TO: Troy Kelts, Galloway & Company
FROM: Stacey Nerger, Senior Planner
DATE: February 22, 2024
SUBJECT: The Exchange Lot 1 – Site Plan
Review Comments 03

EXCHANGE LOT 1 SITE DEVELOPMENT PLAN

Description: **The Exchange L1 - Site Plan Amendment Addition and Remodel**

7 EXISTING LANDSCAPE
1"=20'

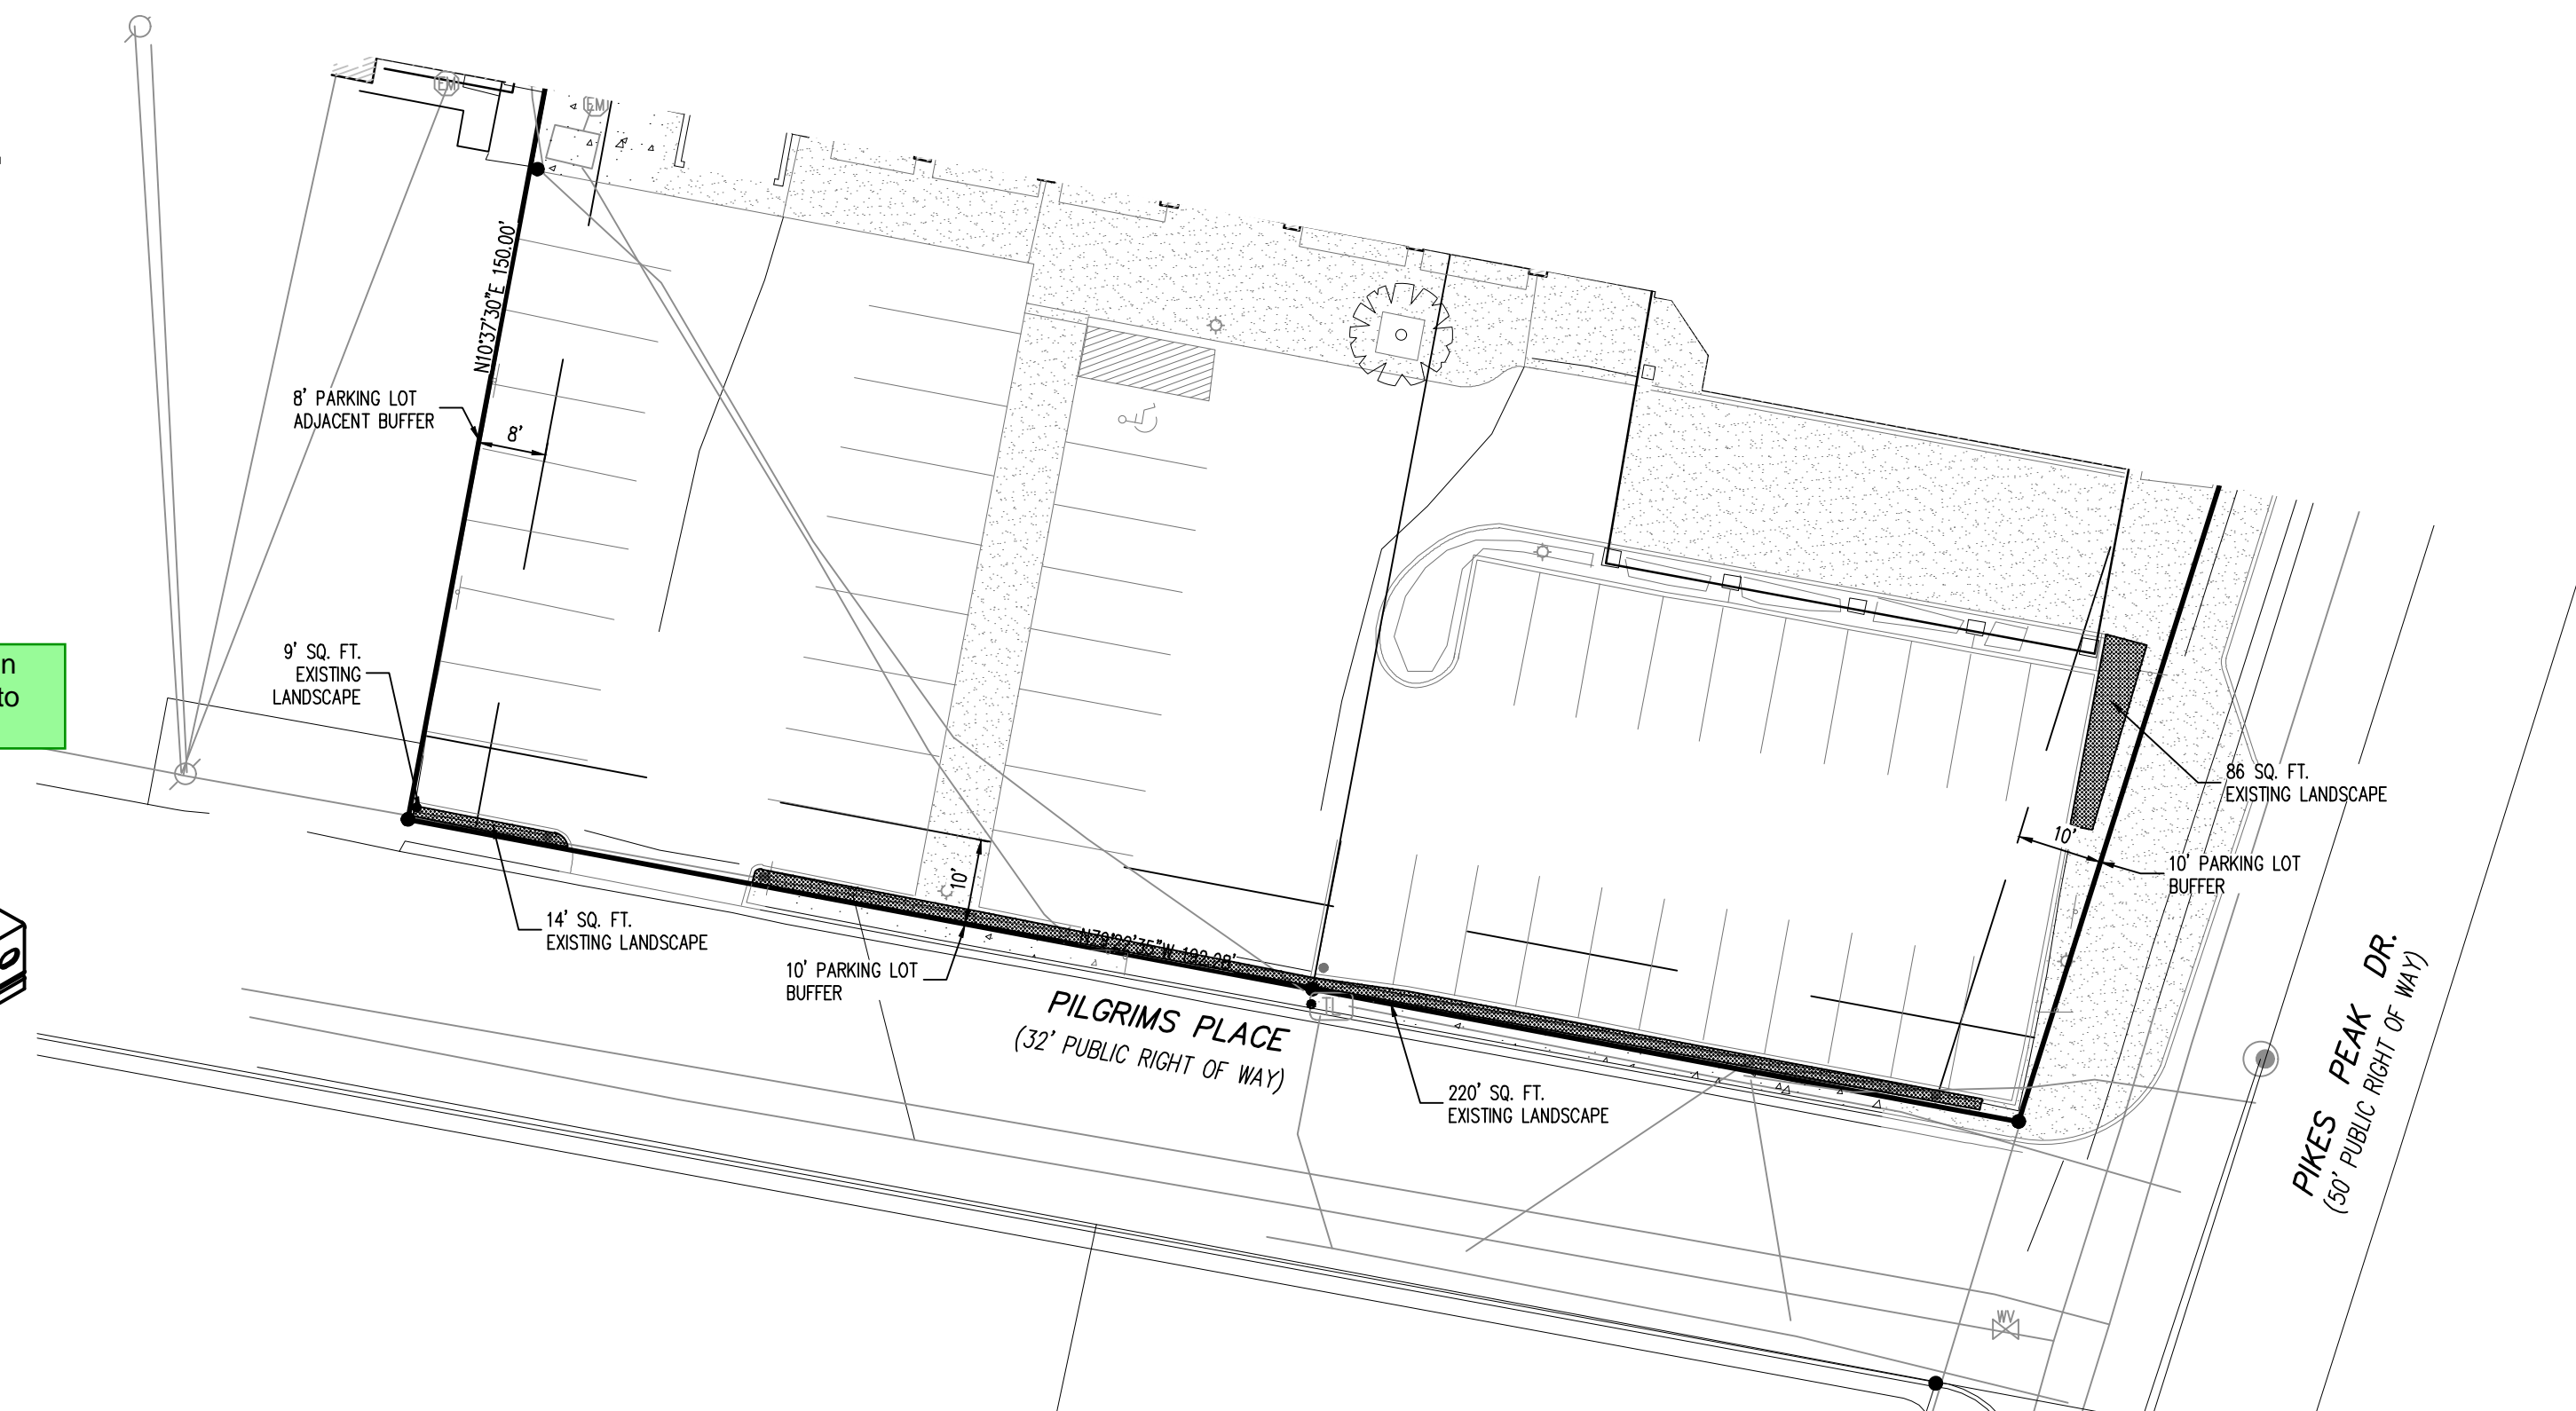
As noted in previous comments the maximum distance between trees is 35'. If there is an argument for why this requirement cannot be met, please provide a detailed note explaining why.

Staff does not see where this double star is used in this table. If it is used and staff just missed it, disregard. If it does not appear on this table, please delete.

Please improve the clarity of this note to provide the reason the requirement cannot be met. May require two notes, one for streetscape and one for adjacent Parking lots

Staff recognizes the note at the bottom of the table, but the note is not clear. Please expand to explain why this requirement cannot be met (Utilities, existing hardscape, ect.)
Note has been updated to provide more clarity

For the parking lot perimeter, please add an additional column that outlines the additional shrubs and grasses proposed.

Maximum distance between trees has been updated

Double star has been relocated to the individual items in the "Existing" column instead of just the title for clarity

New rows added to show the additional shrubs and grasses
